ADDENDUM NO. 02

Project:
Sheridan HS and MS School Renovation Project

Owner:
Sheridan Community Schools
24795 Hinesley Road
Sheridan

This Addendum #02, Dated 09.12.2025, forms part of the contract documents and modifies the original Bidding Documents dated 08.15.2025. Please acknowledge receipt of this Addendum in the space provided on the Bid Form. Failure to acknowledge this Addendum may subject the Bidder to disqualification.

1 GROUND FLOOR - FINISH PLAN - UNIT B
A801B SCALE: 1/8" = 1'-0" NORTH

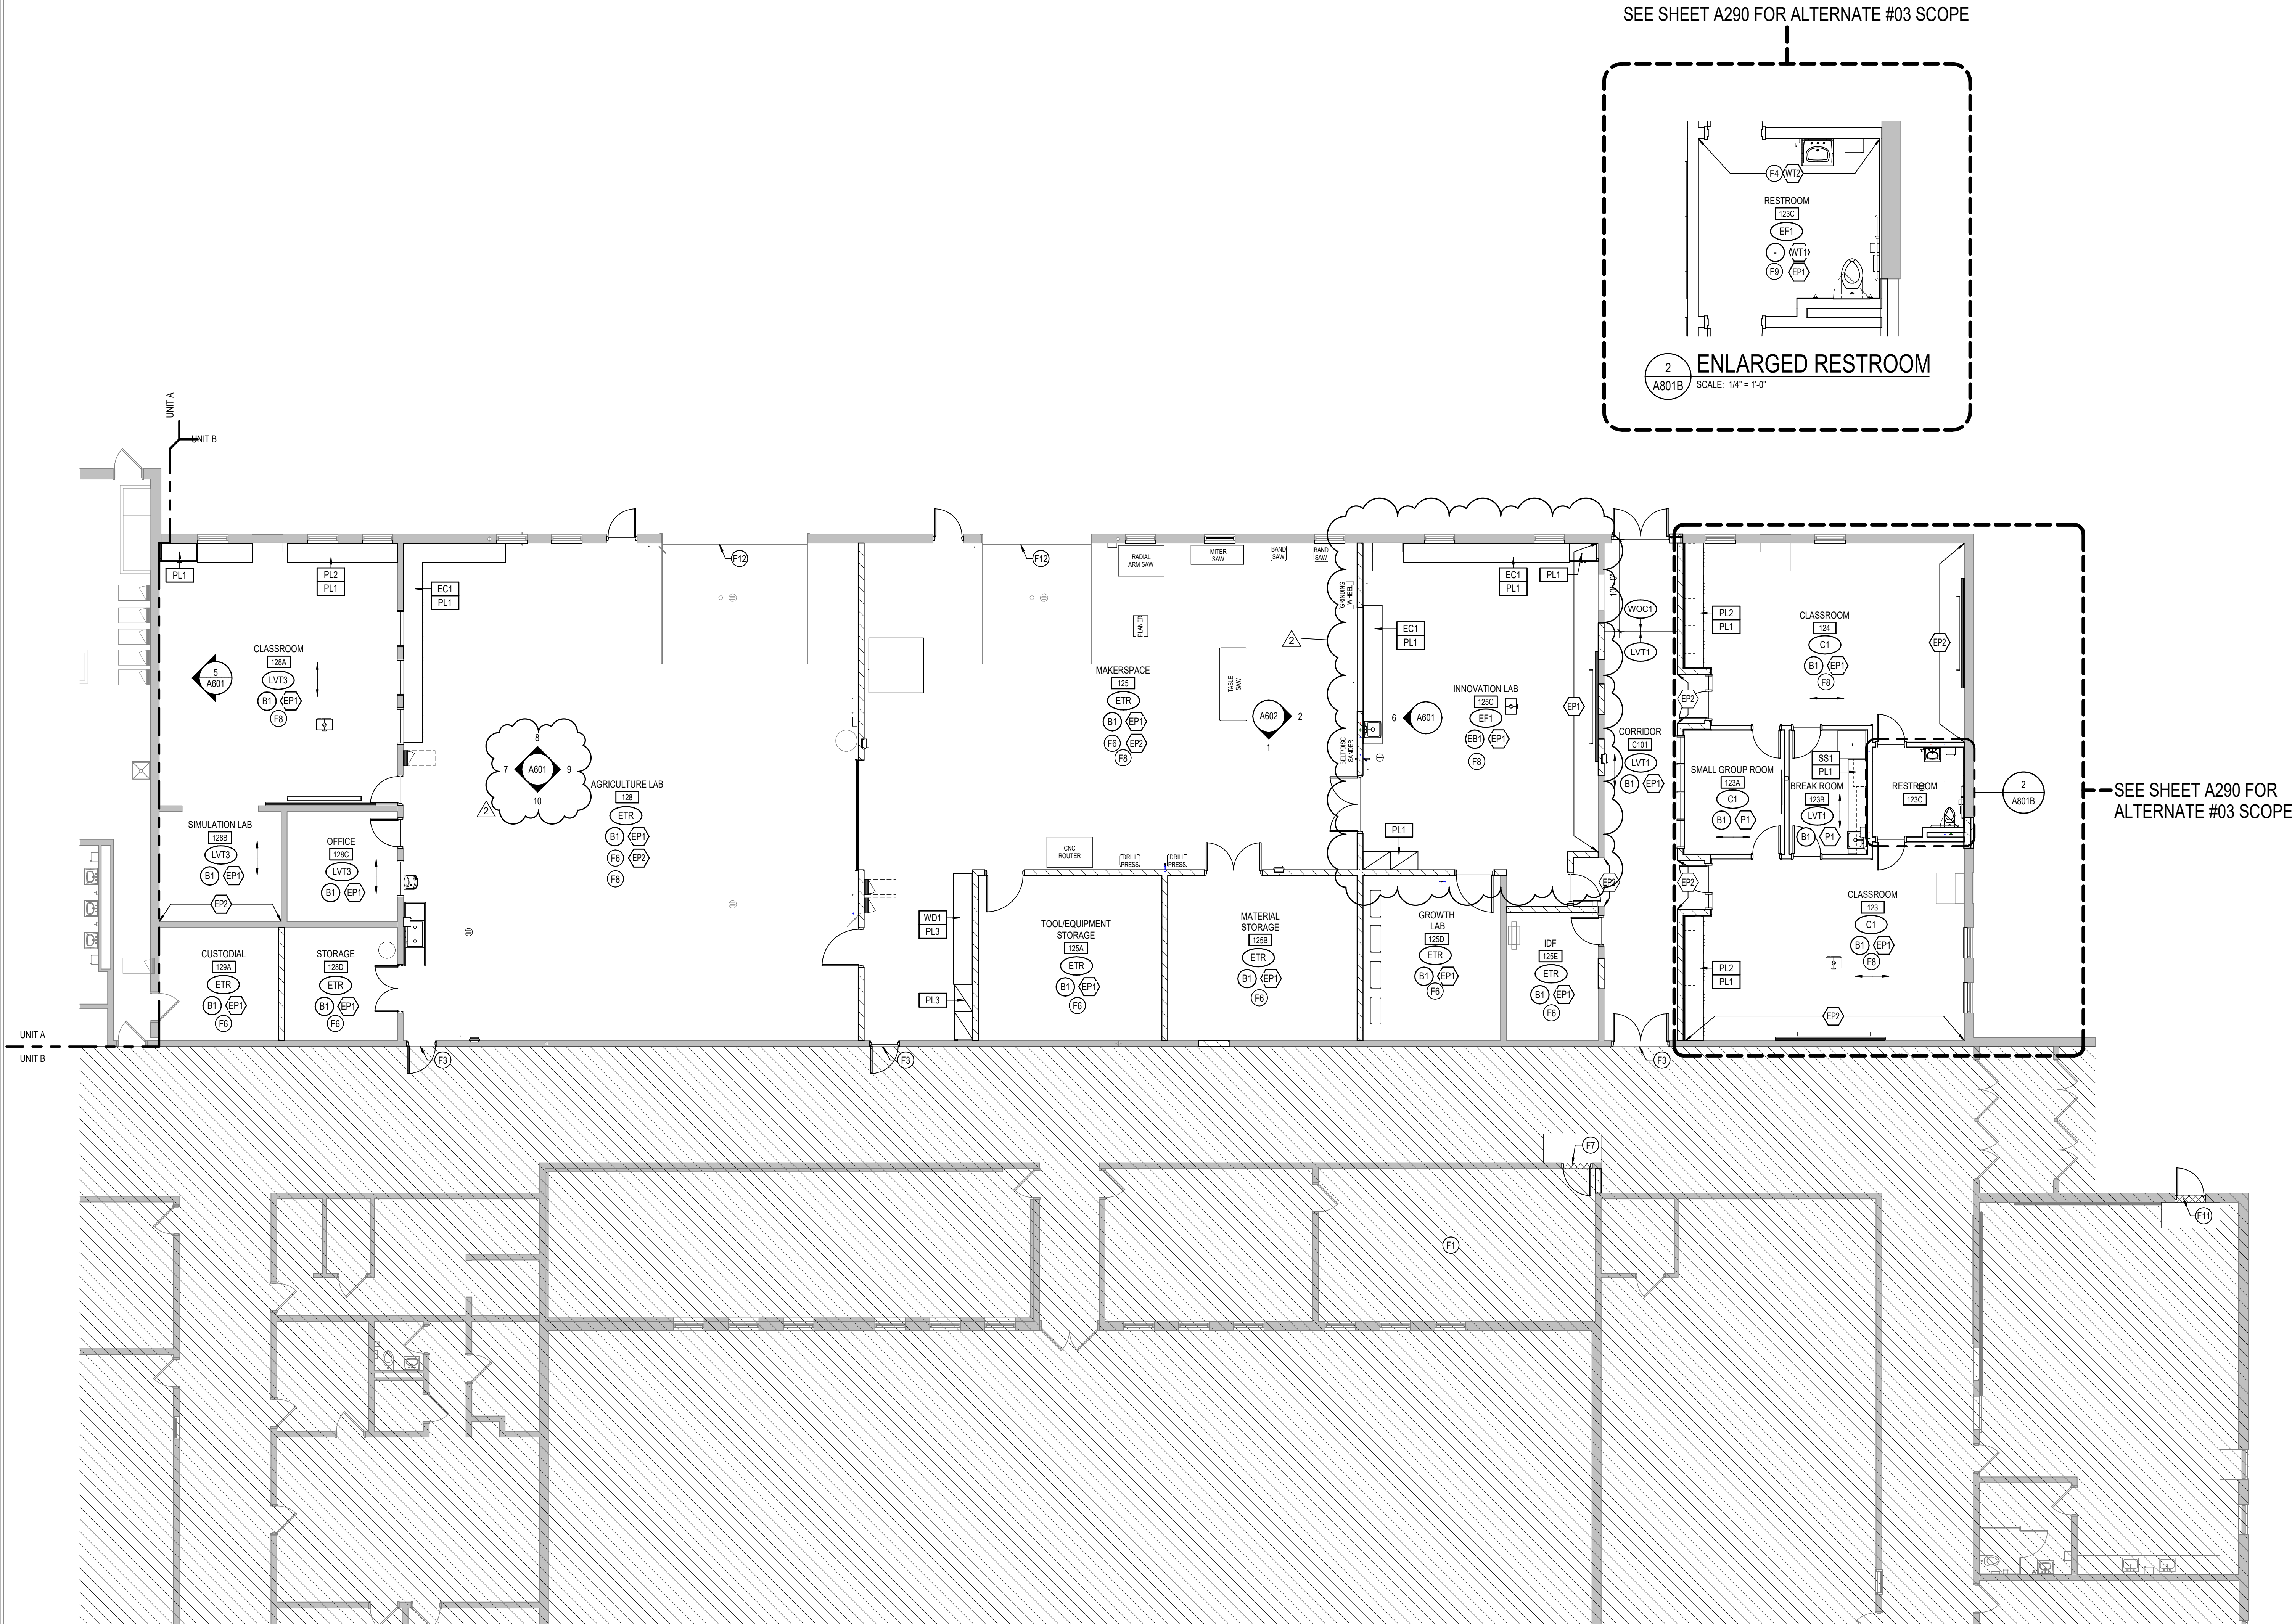
- A. Add Elevation 6/A601.
- B. Revised Elevation numbers.

DRAWING NUMBER
PD201A

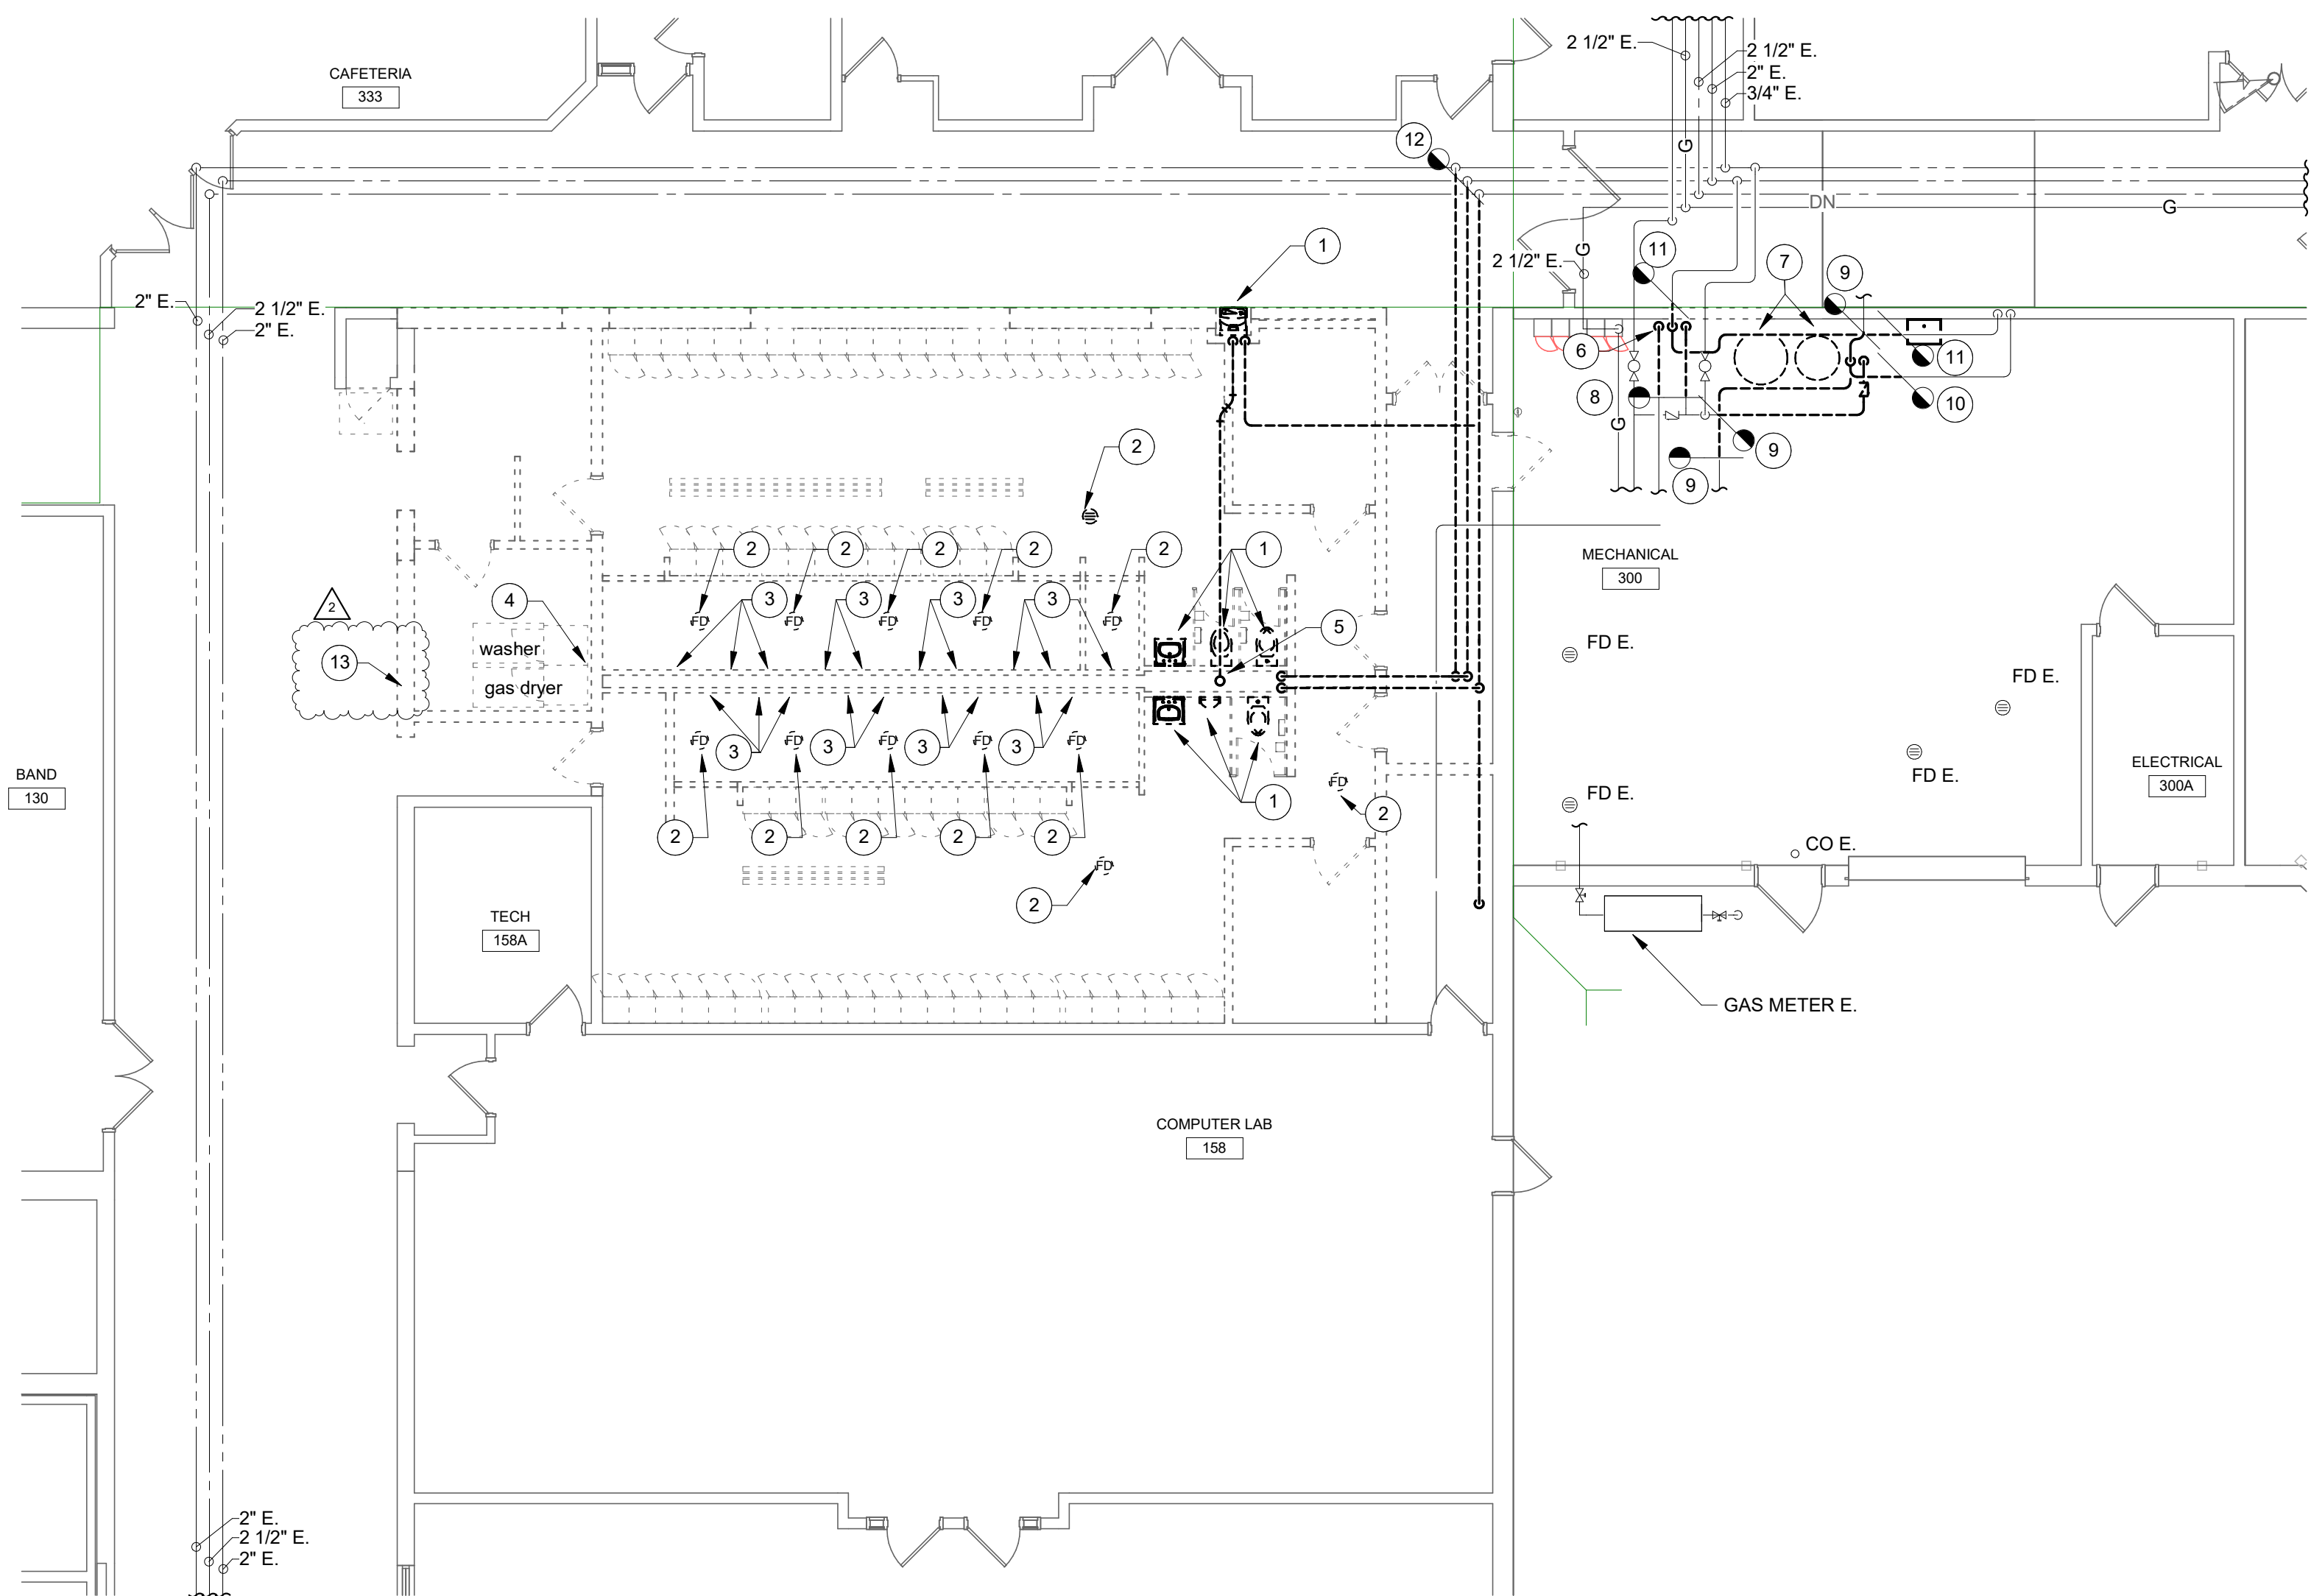
- A. Plan Note #13: REMOVE THERMOSTATIC MIXING VALVE AND PIPING COMPLETELY.
- B. Plan Note #13 refers to mixing valve in corridor wall. See attached sheet.

10. Bid Item #13 Mechanical Contractor shall be responsible for Plan Note 13 on Drawing PD201A.
11. Bid Item #12, Fire Protection Contractor shall furnish and install concealed style sprinkler heads in the new classrooms and office area. All heads except those that go in rooms with no ceilings, those can be the exposed type.

**GROUND FLOOR UNIT A - PLUMBING**
SCALE: 1/8" = 1'-0"

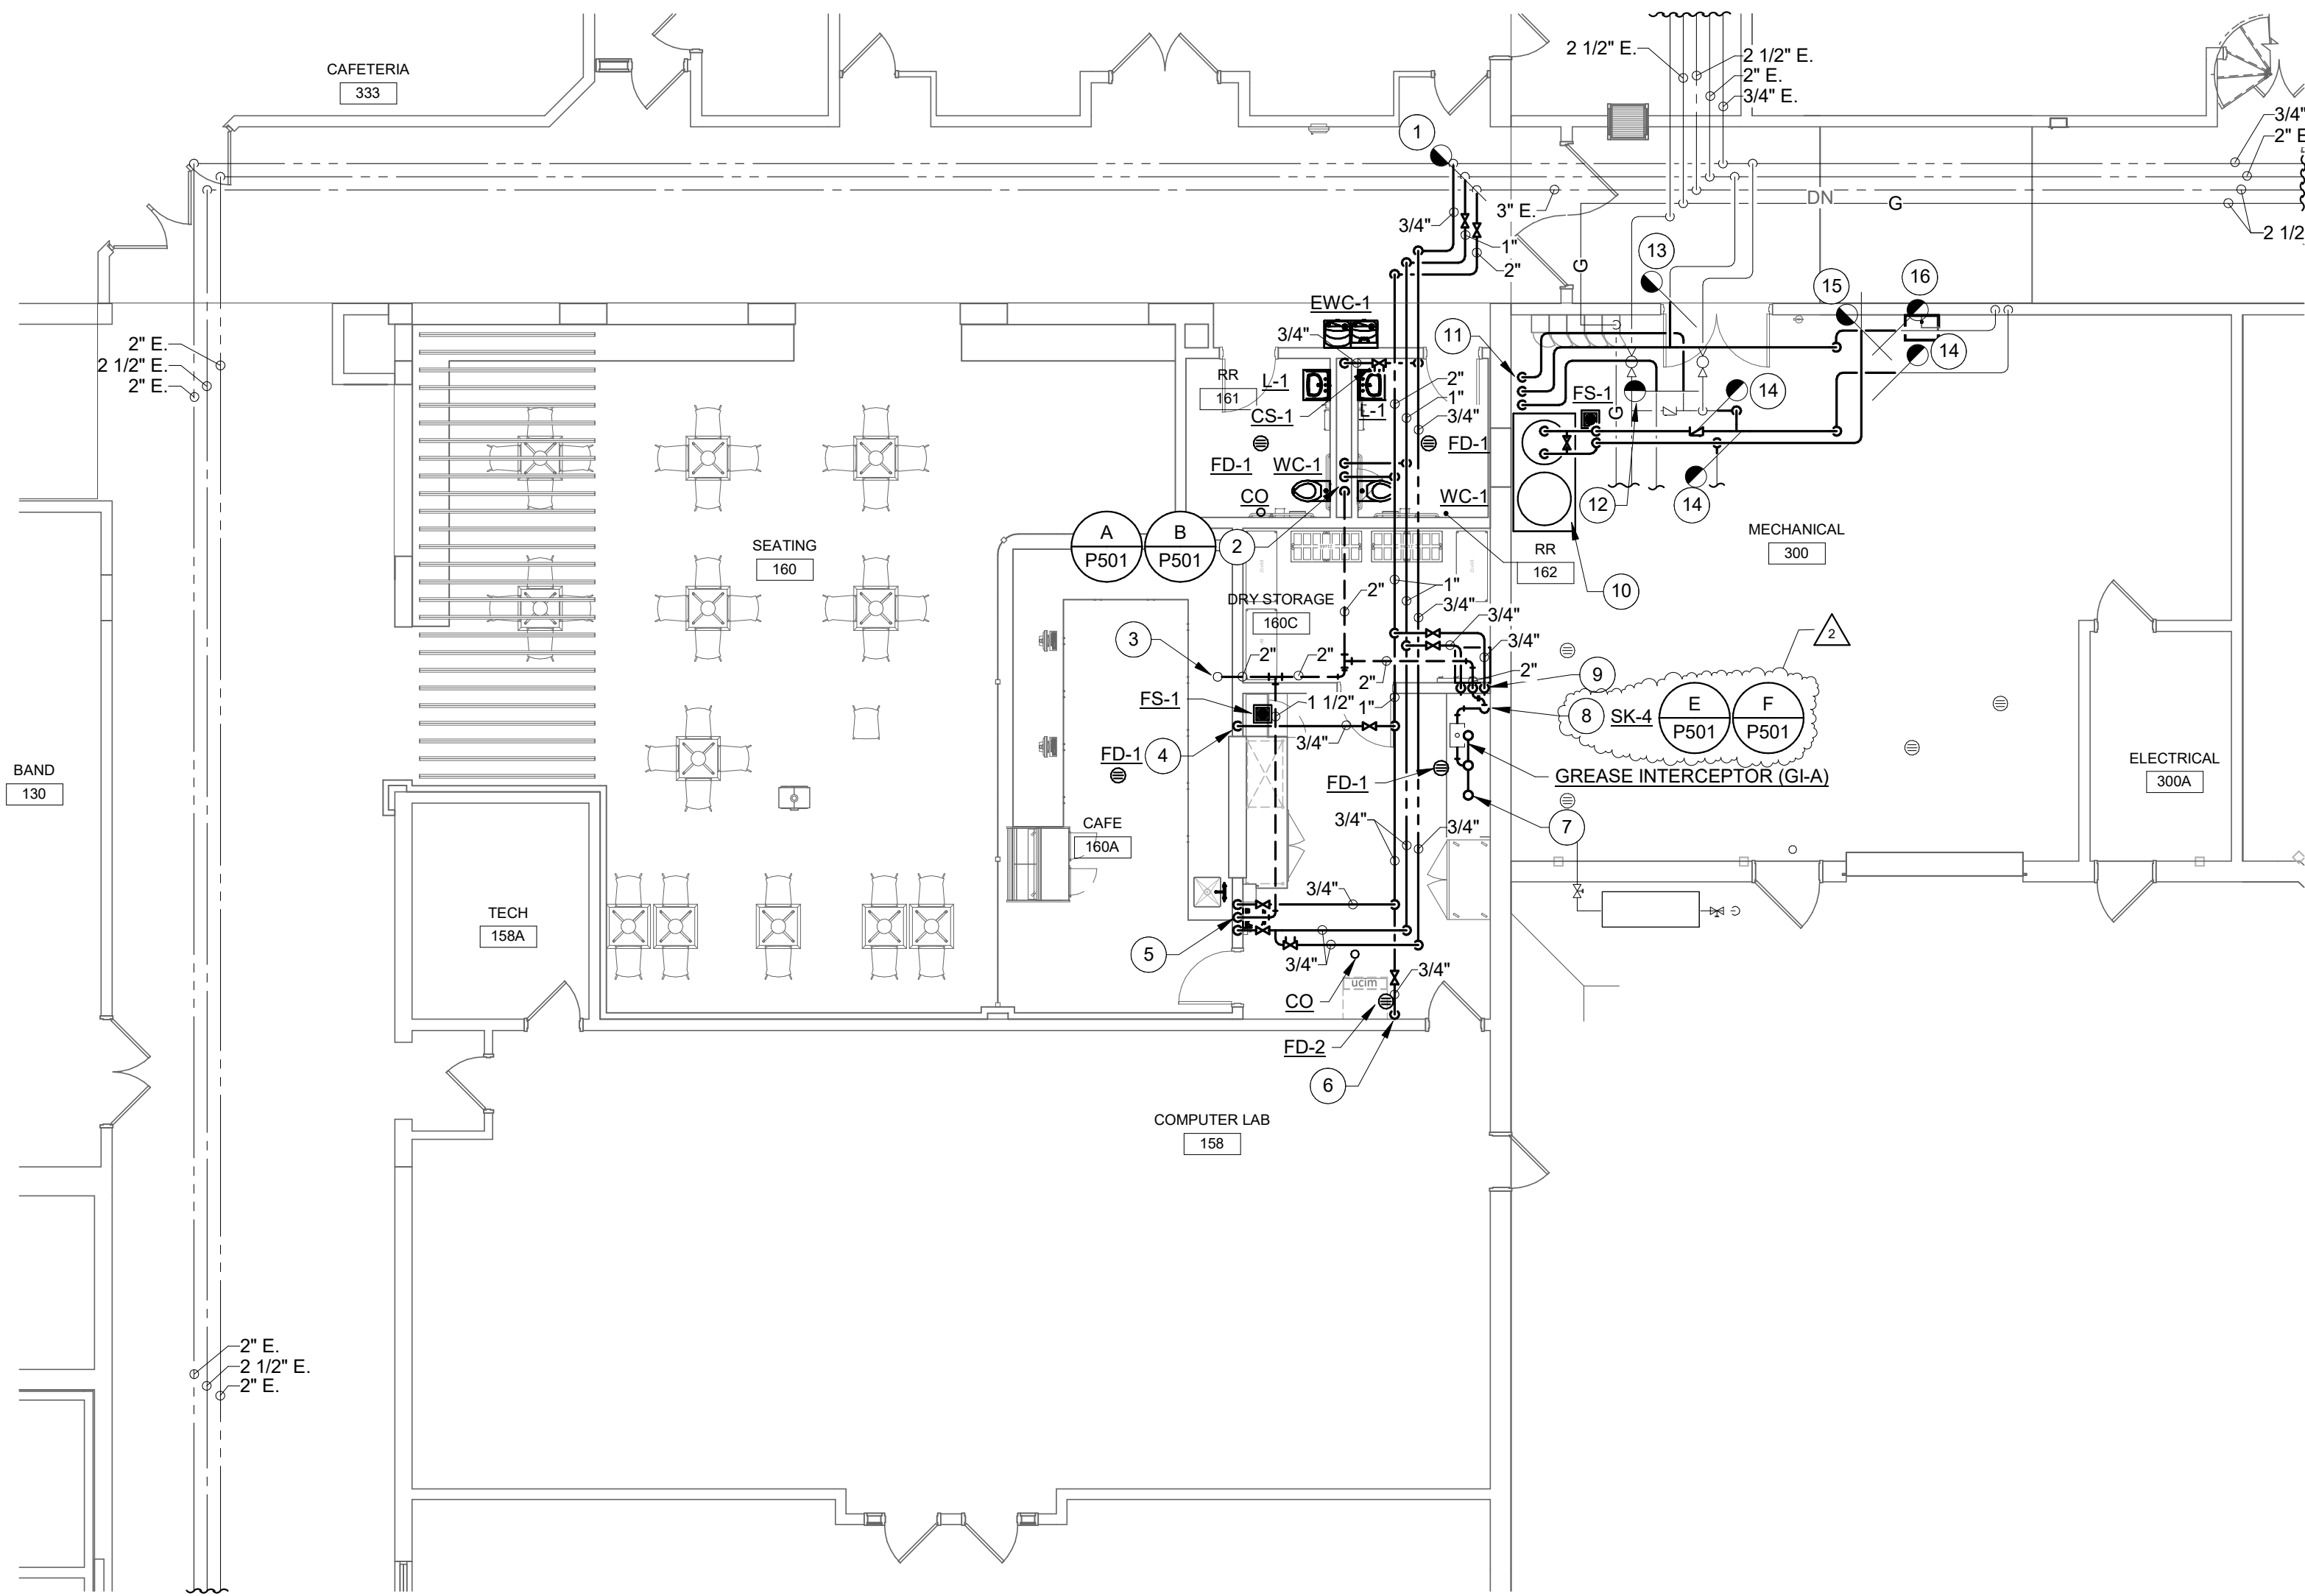
- A. Change SK-3 to SK-4
